TOWNSHIP OF FRANKLIN
Board of Adjustment
Agenda
Thursday, May 7, 2026

UKRAINIAN ORTHODOX CHURCH OF U.S.A / ZBA-25-00008

RE: ***Ukrainian Orthodox Church of U.S.A.
Parking Lot Improvements
Preliminary & Final Major Site Plan
Report #3
Engineering
Block 469, Proposed Lot 1.09
135 Davidson Avenue
Franklin, New Jersey
Our File: MFRZ0469.03/600.01
Application # ZBA-25-00007***

Figure 2: FEMA Special Flood Hazard Area along stream and in roadway

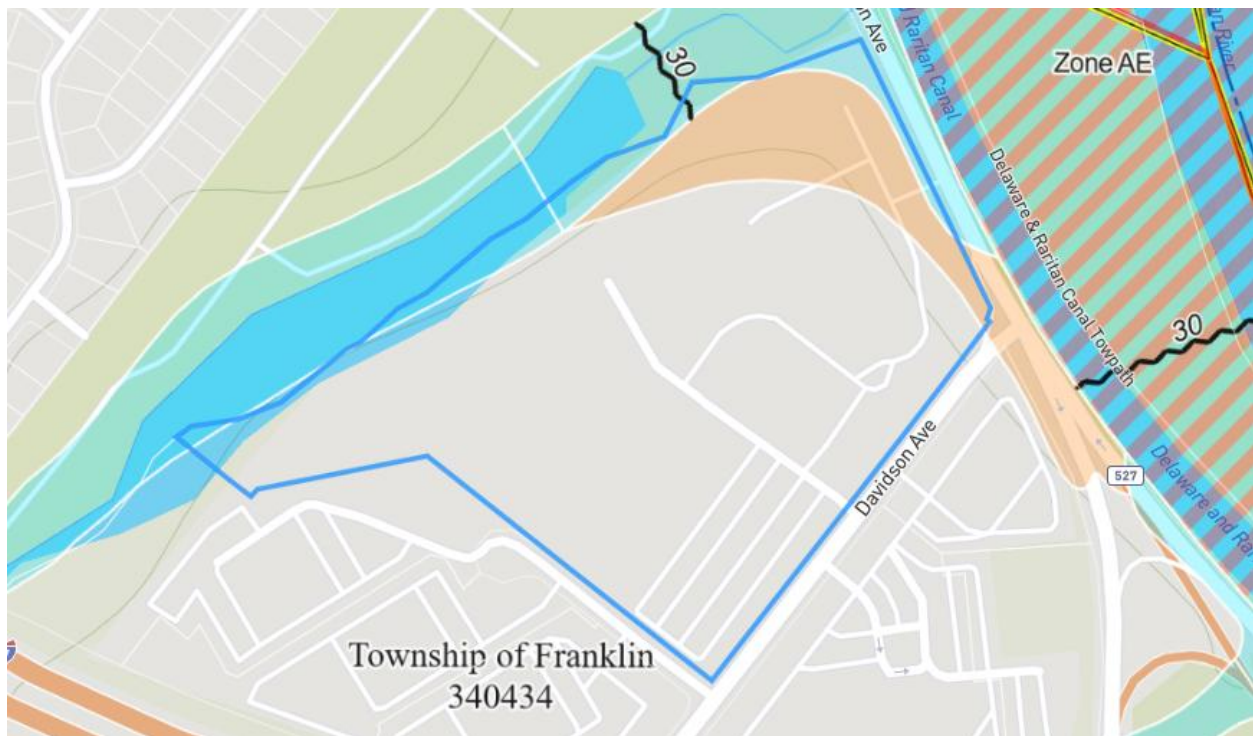
- FEMA records show a Special Flood Hazard Area on a portion of the property.
- GIS information provided by the NJDEP indicates that wetland areas may exist on a portion of the property.
- The applicant is proposing to subdivide the property into two lots, fully conforming in size and all bulk requirement for the zone. A variance is required for expansion of a non-conforming use; the church and cultural center are preexisting non-conforming uses in the B-I Zone.
- It is presumed that the applicant is proposing to perfect the minor subdivision by deed filing with the County.

Figure 5: Davidson Avenue Frontage

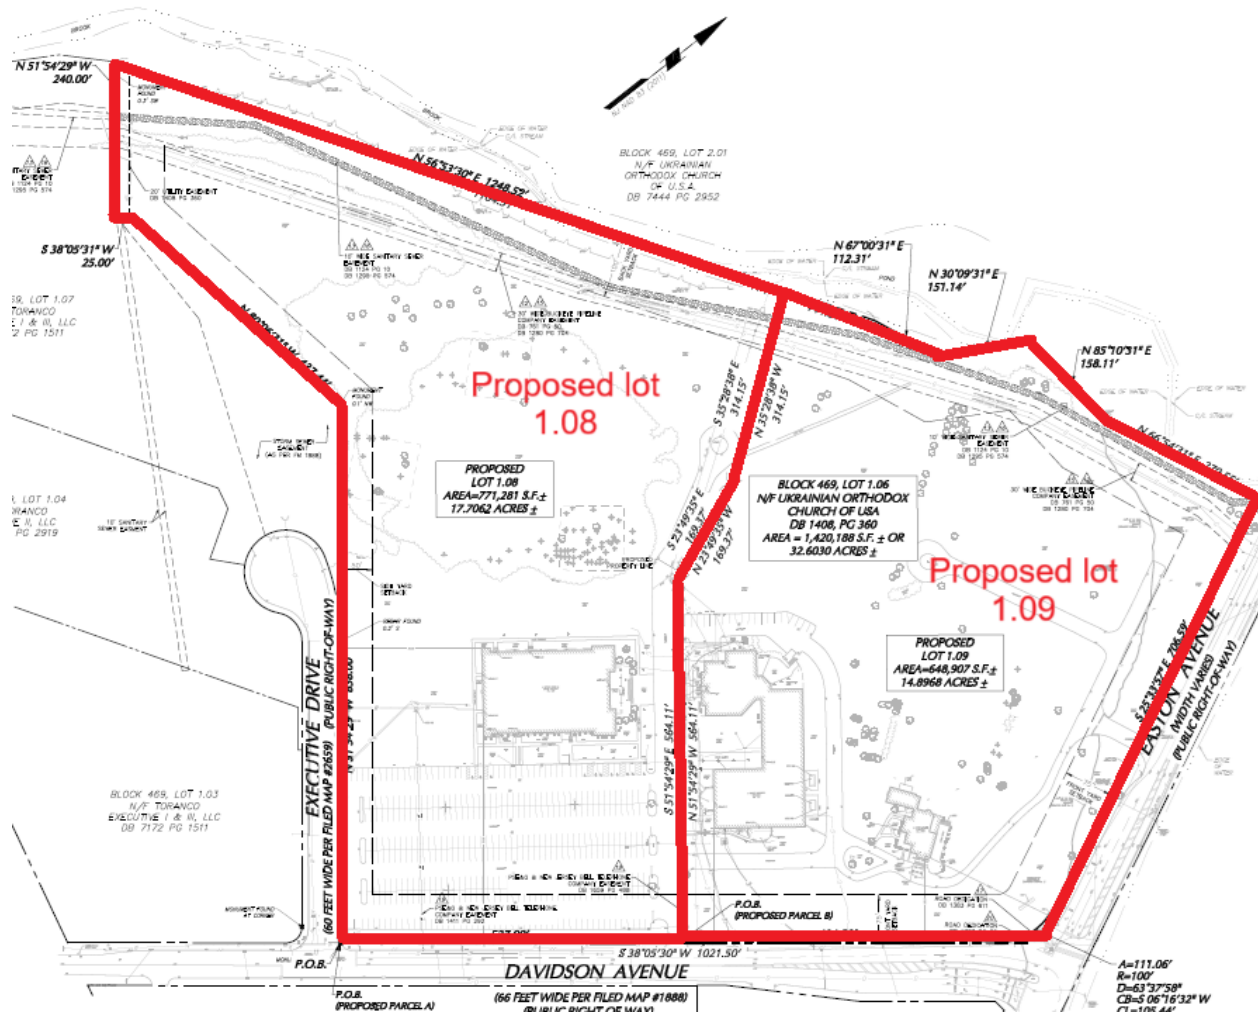
provided in Figure 5. If the Board is inclined to consider approval of the application (including the request D(1) use variance) I would suggest that the Board require similar along the site's Davidson Avenue frontage.
